(34) RUS Form 515, issued September 17, 2001, Telecommunications Systems Construction Contract (Labor and Materials).

DEPARTMENT OF AGRICULTURE
Rural Utilities Service
7 CFR Part 1755
RUS Standard for Service Installations at Customer Access Locations
AGENCY: Rural Utilities Service, USDA.
ACTION: Final rule.

SUMMARY: The Rural Utilities Service (RUS) amends its regulations on Telecommunications Standards and Specifications for Materials, Equipment and Construction, by rescinding RUS Bulletin 345-52, RUS Standard for Service Entrance and Station Protector Installations, PC-5A, and codifying the revised standard in the Code of Federal Regulations (CFR) as the RUS Standard for Service Installations at Customer Access Locations. The revised standard updates the installation methods used for installing aerial and buried service drops, network interface devices, fused primary station protectors, and protected building entrance terminals at customer access locations as a result of technological advancements made in

FIGURE 3
CABLE ENTRANCES AND RUNS IN BUILDINGS

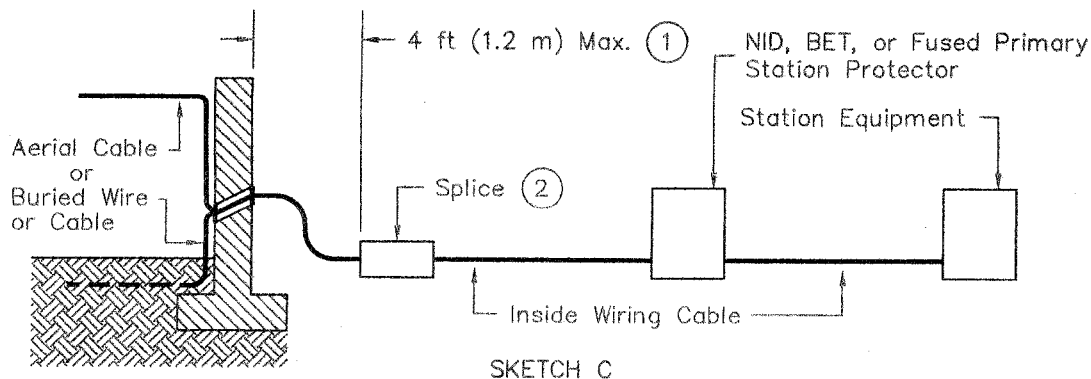
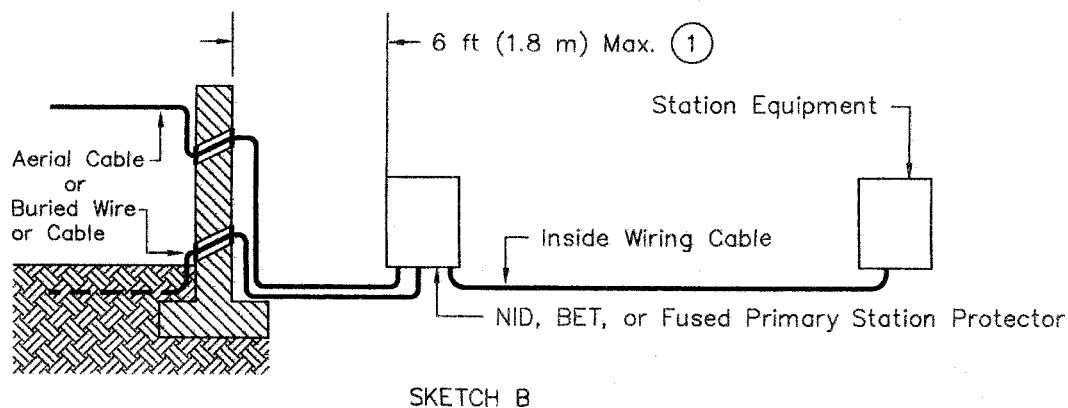
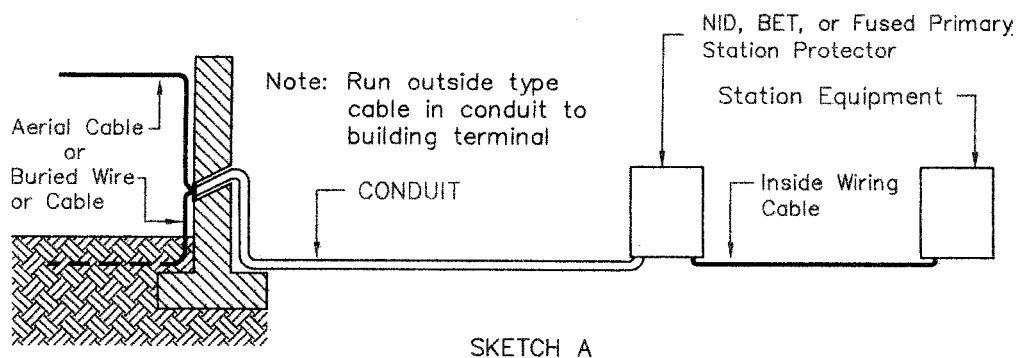
Response: Based on the respondent's comments, RUS decided to review all the figures and construction drawings in §§ 1755.500 through 1755.510 for editorial and technical correctness. As a result of RUS's review the following actions concerning the figures and construction drawings were taken:

2. Figures 3 and 8 have been revised to reference the 1999 issue of the *NEC*® instead of the 1996 issue of the *NEC*®, which is no longer in effect.

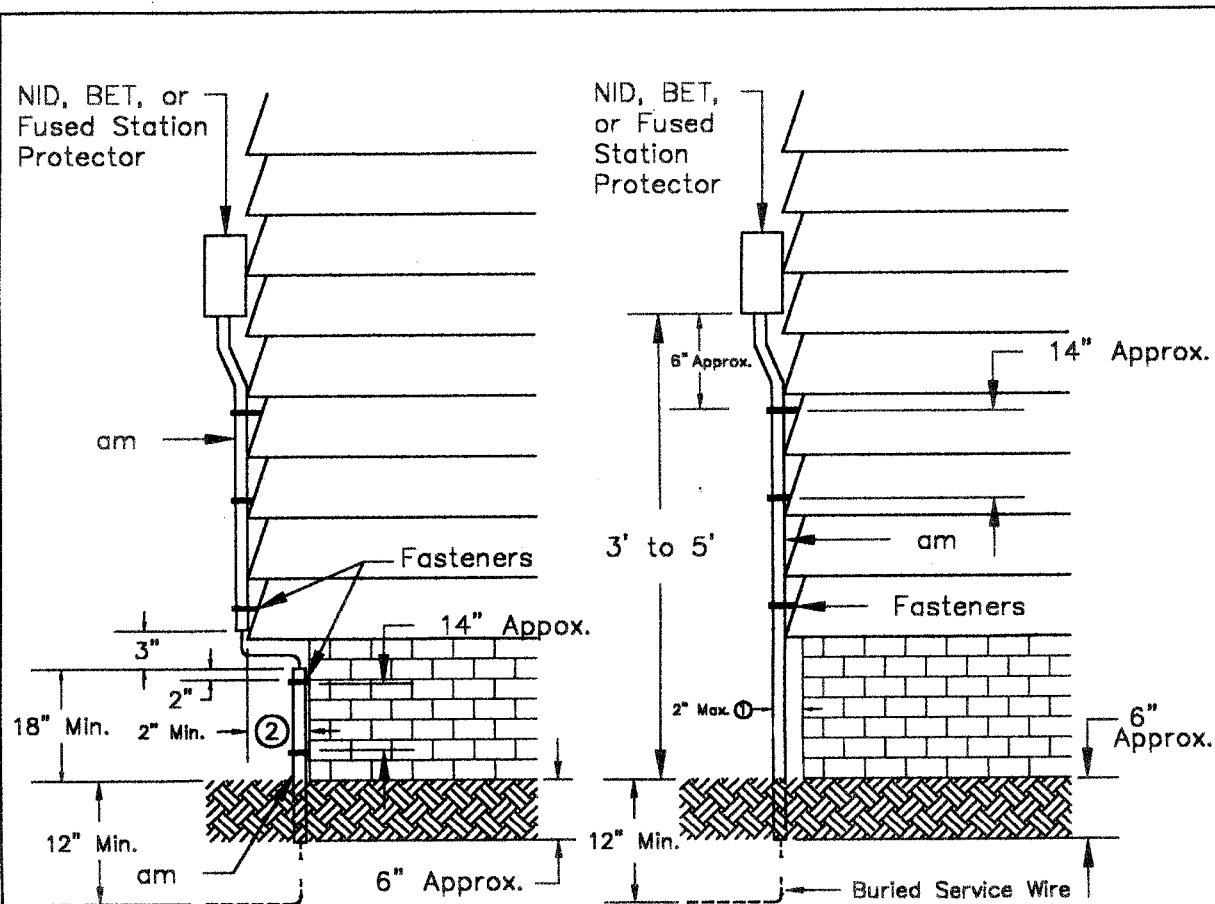
7. The "BM50 Assembly Unit Drawing" is being inserted to replace Construction Drawing 912 in § 1755.510. The reason for this change is attributed to current installation practices. Aerial service wires (from buried cables) are installed in accordance with information provided in the BM50 Assembly Unit Drawing

not the 912 Construction Drawing. The major difference between the BM50 Assembly Unit Drawing and the 912 Construction Drawing is that the BM50 drawing eliminates the aerial service installation information from the drawing and indicates that the buried plant housing is paid under the buried plant housing assembly unit (BD).

ITEM	MATERIAL	NO. REQ'D
am	Guard, buried service (including fasteners)	1
		RURAL TELECOMMUNICATIONS CONSTRUCTION PRACTICES BURIED SERVICE GUARD
		Scale: NTS
		March 2001 BM83

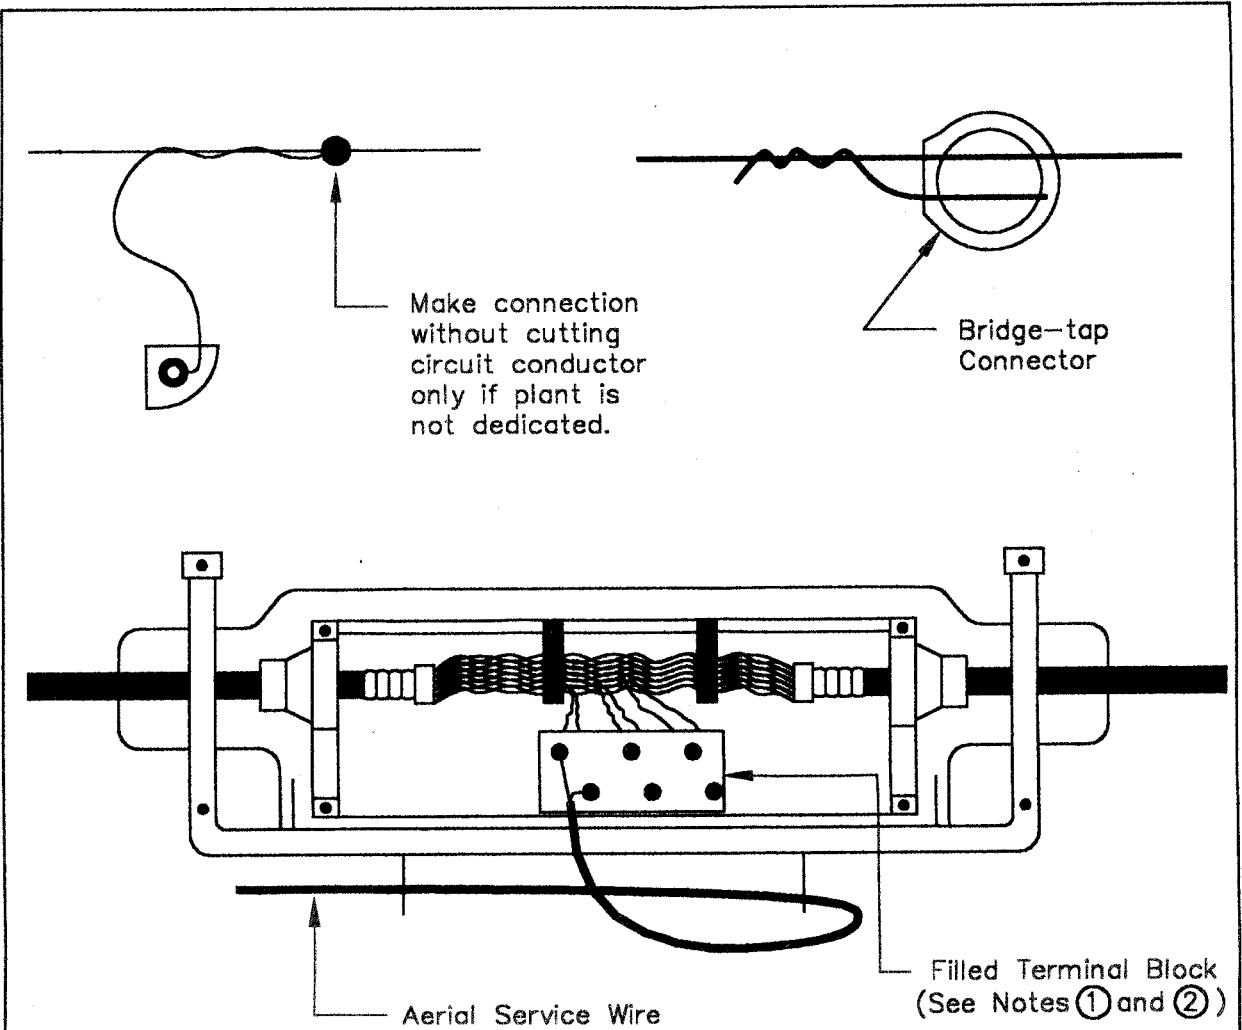
The same respondent recommended that Note 2 of the BM83 Assembly Unit Drawing in § 1755.510 be modified to allow the optional installation of a flexible service guard when an obstruction of greater than 2 in. (51 mm) is encountered instead of requiring two service guards.

Response: After much discussion and consideration, RUS agrees with the comment and is modifying Note 2 of the BM83 Assembly Unit Drawing in § 1755.510 to allow the optional installation of a flexible conduit when obstructions of greater than 2 in. (51 mm) are encountered. The revised Note 2 of the BM83 Assembly Unit Drawing will read as follows: "Where an obstruction of greater than 2 in. is encountered, the buried service guard (item am) shall be divided as shown (from the NID, BET, or fused protector to the obstruction, and from 3 in. below the obstruction to 6 in. below the ground). In lieu of divided service guards (item am), a continuous flexible conduit may be used from the NID, BET, or fused protector to 6 in. below the ground."

- ①. Where an obstruction of less than 2 in. is encountered, the buried service guard (item am) shall extend from the NID, BET, or fused protector to 6 in. below the ground.
- ②. Where an obstruction of greater than 2 in. is encountered, the buried service guard (item am) shall be divided as shown (from the NID, BET, or fused protector to the obstruction, and from 3 in. below the obstruction to 6 in. below the ground). In lieu of divided service guards (item am), a continuous flexible conduit may be used from the NID, BET, or fused protector to 6 in. below the ground.
- ③. For converting English units to metric units use 1 in. = 25.4 mm and 1 ft = 0.3048 m.

RURAL TELECOMMUNICATIONS CONSTRUCTION PRACTICES			
AERIAL PLASTIC CABLE DETAILS OF WIRE			
CONNECTIONS TO FILLED TERMINAL BLOCKS			
Scale: NTS		March 2001	
		312-1

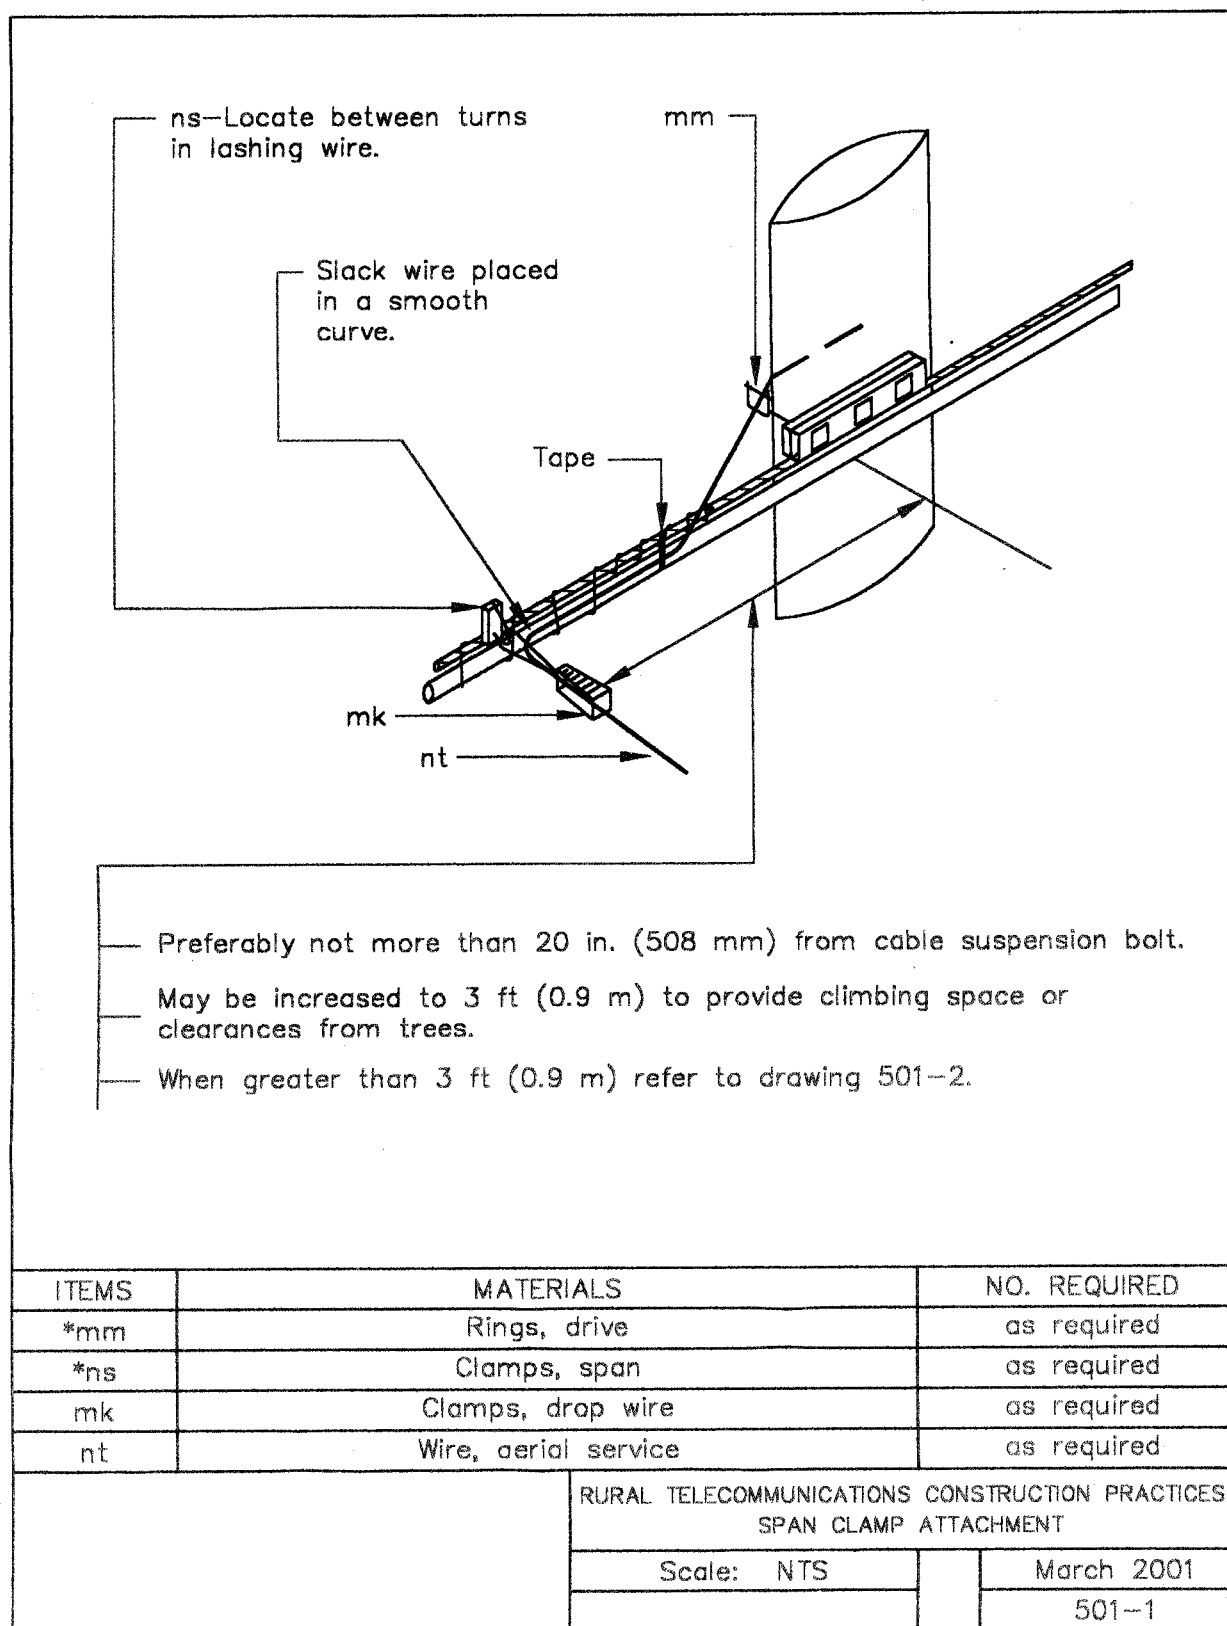
The final comment from the same respondent questioned the editorial and technical correctness of Construction Drawings 312-1, 501-1, 501-2, 702, 958, and 962 in § 1755.510.

4. Construction Drawing 312-1 in § 1755.510 is being changed by adding the respondent's recommended language of "only if plant is not dedicated" to the proposed language concerning one of the methods of terminating the lead-out wires of terminal blocks to distribution cable conductors. This new language will read as follows: "Make connection without cutting circuit conductor only if plant is not dedicated."
